MODEL JR-S300

INTEGRATED STEREO RECEIVER

MODEL JR-S300

SUPPLEMENT

Removal of Front Panel

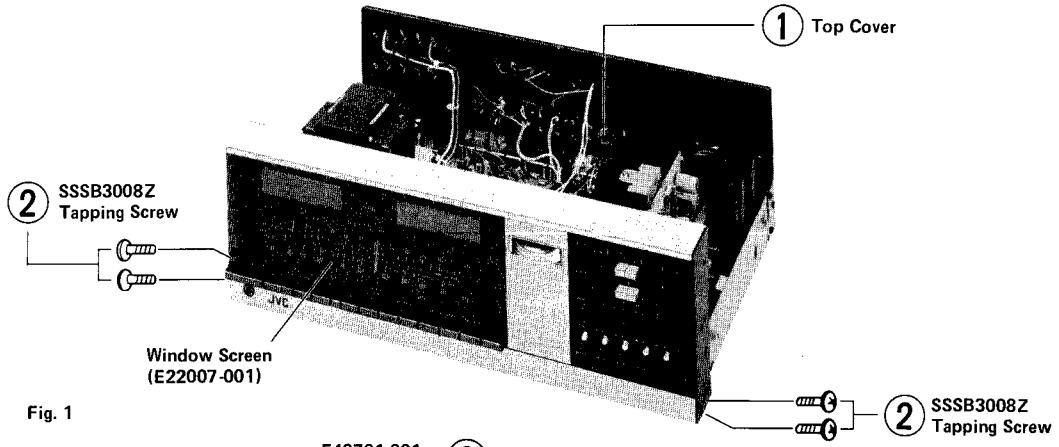
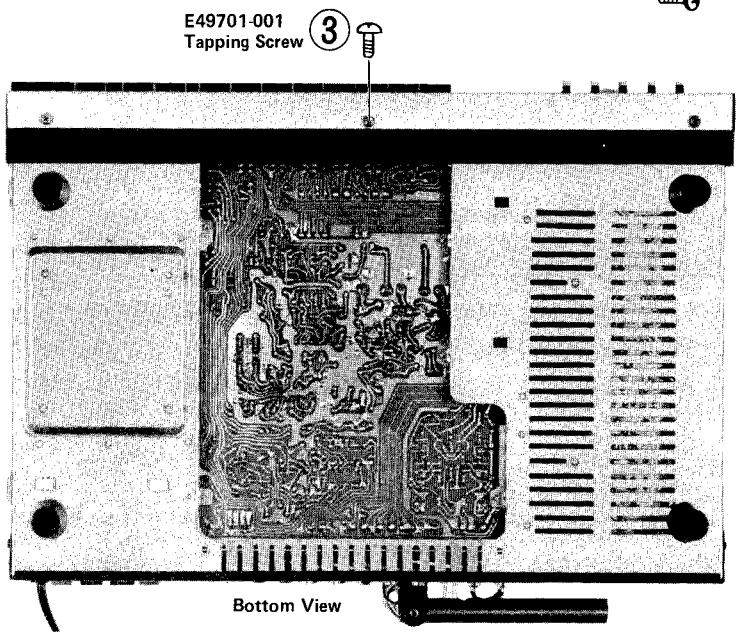
1. Remove the top cover, item No. ① . Refer to the removal of top cover on page 3.
2. Remove the dial pointer carefully according to the steps below:
   a. Slide the dial pointer to the center position of the dial rail.
   b. Remove the dial cord from the dial pointer. Do not pull the dial cord strong.
   c. Remove the dial pointer from the dial rail carefully.
3. Remove one screw, item No. ③ located on the bottom of the front panel.
4. Remove 4 screws, item No. ② located on both sides of the front panel.

Note for step 2: Refer to Fig. 9 of the dial stringing procedure on page 7 when replacing the dial pointer onto the dial rail.

In Case of Removing the Window Screen from the Front Panel:
Remove 4 hexagonal screws, item No. 3 located on the window screen. Refer to Fig. 6 on page 5.
Warning: Use hexagonal wrench (size 3/32") and do not screw in excessively when replacing the window screen.

4-(1) Front Panel at page 5

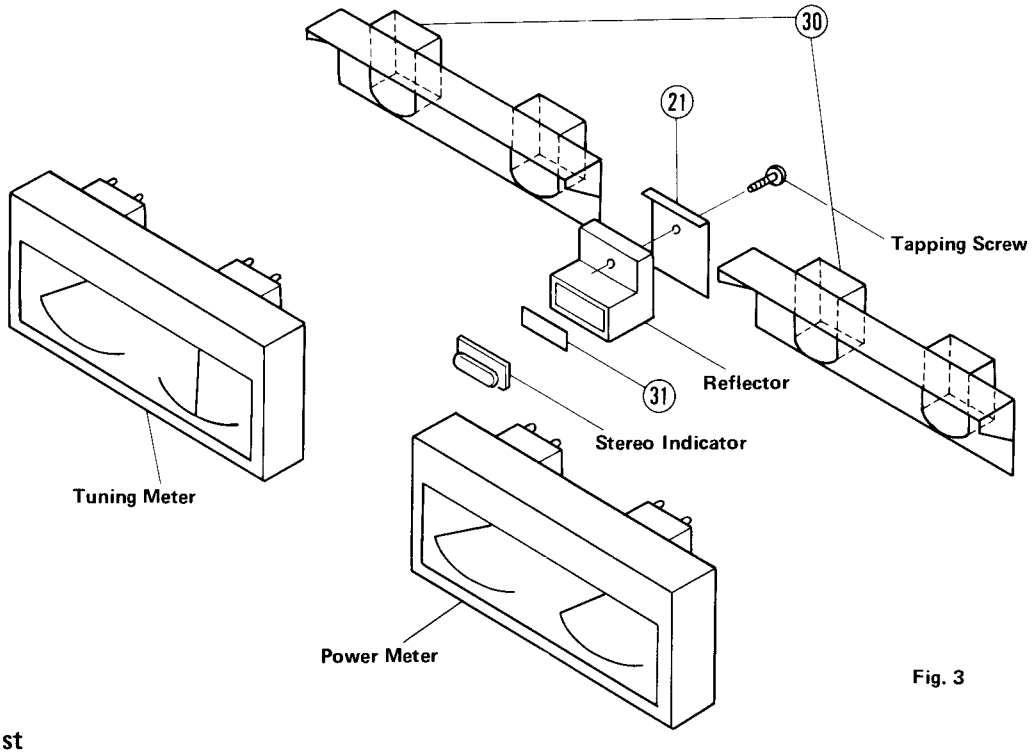
Item No.	New Part Number	Original	Description
5	E60880-002	E60880-001	Slide Knob
13	E34423-002	E34423-001	Meter Holder
15	QLP4101-006	QLP4101-004	Pilot Lamp
18	–Delete–	E46855-039	Color Screen
21	E61220-001	Q03091-105	L Typed Bracket
23	E34422-002	E34422-001	Dial Pointer Ass'y
30	E34545-001	–Not Listed–	Meter Covering
31	E36855-043	–Not Listed–	Color Screen

5. DIAL STRINGING PROCEDURE AT PAGE 7

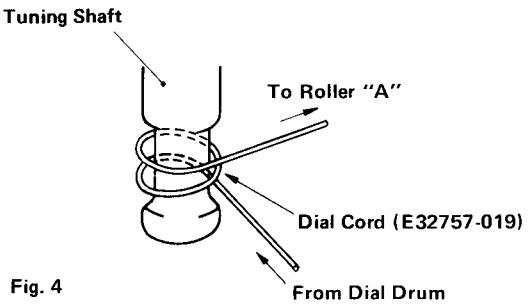
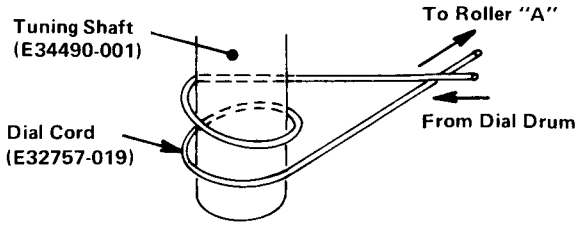
Right

Wrong (original)
